NRC Public Meeting with Industry on Accident Tolerant Fuel

February 27, 2018

Draft ATF Project Plan Public Comments

old & new

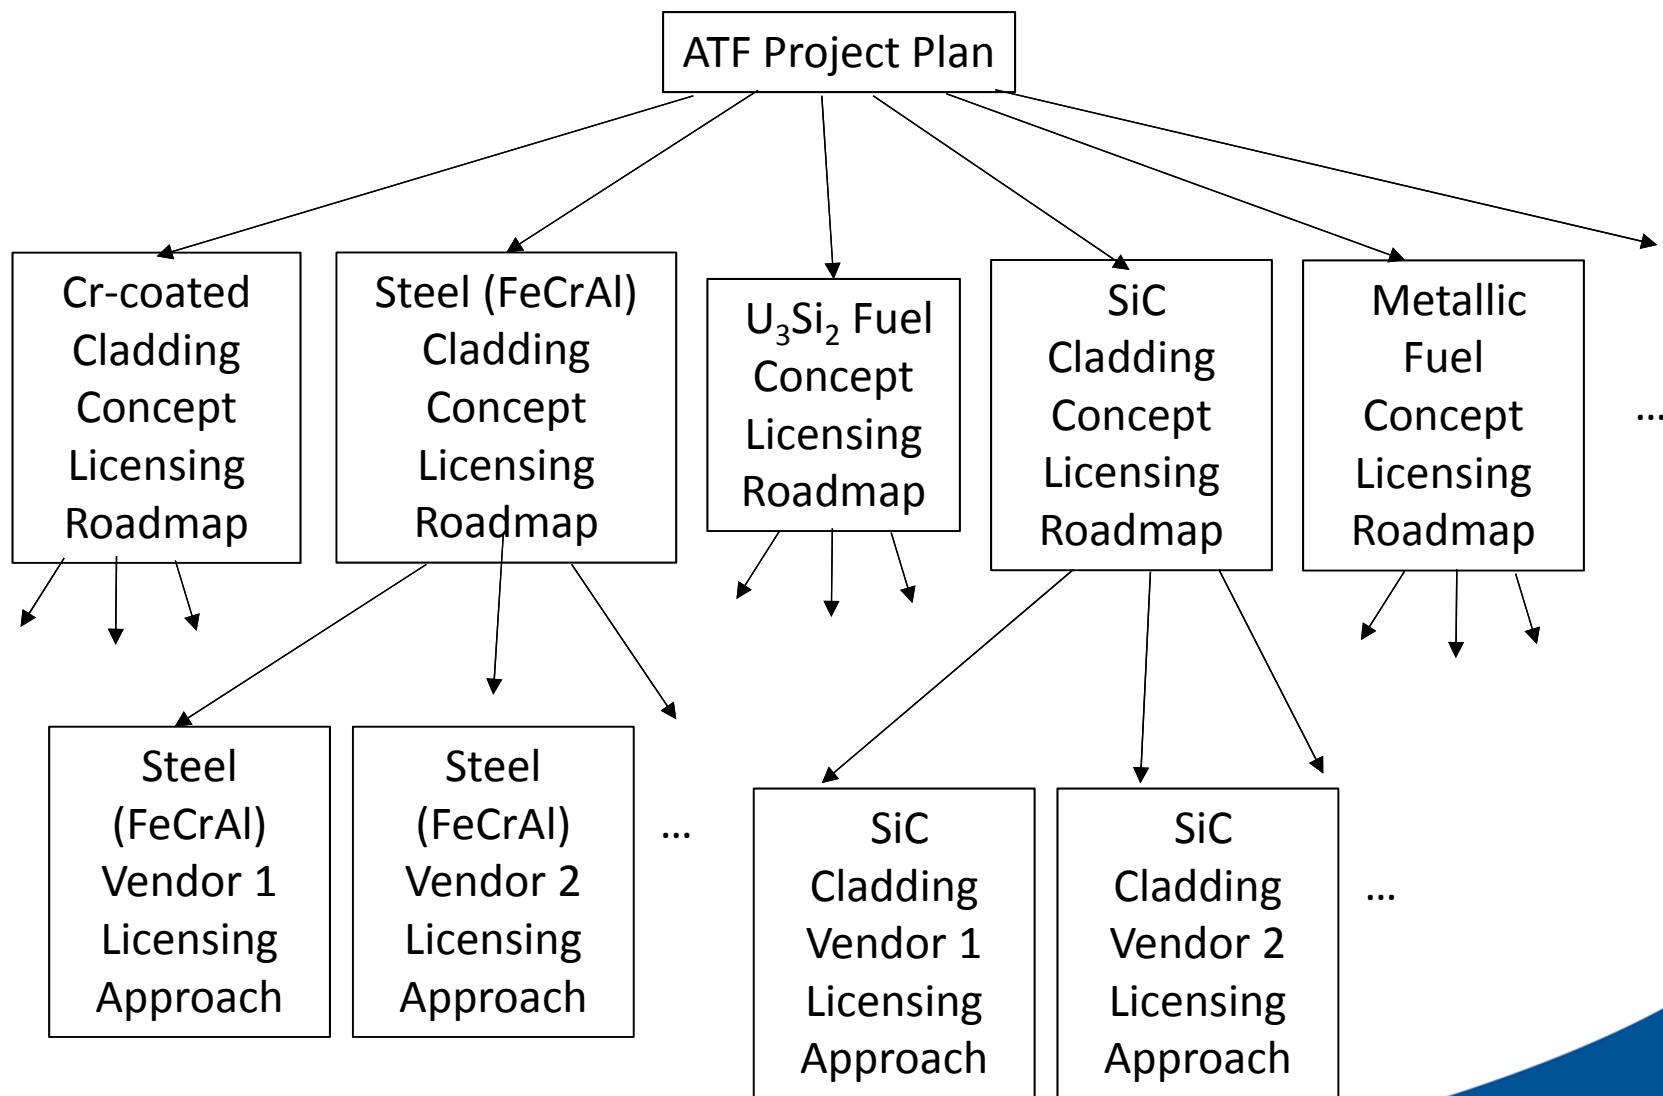
- Comment
 - Plan does not support industry's deployment schedule
 - Staff not employing a graded approach
- NRC response
 - The plan did not present a schedule but rather individual activities, many of which can proceed in parallel
 - The staff is committed to minimizing the lag between the time required to establish the technical bases for safe operation and the completion of licensing activities
 - PIRTs will inform the licensing roadmaps for individual concepts
 - PIRTs will facilitate employing a tailored approach for each concept, thus enabling a graded approach
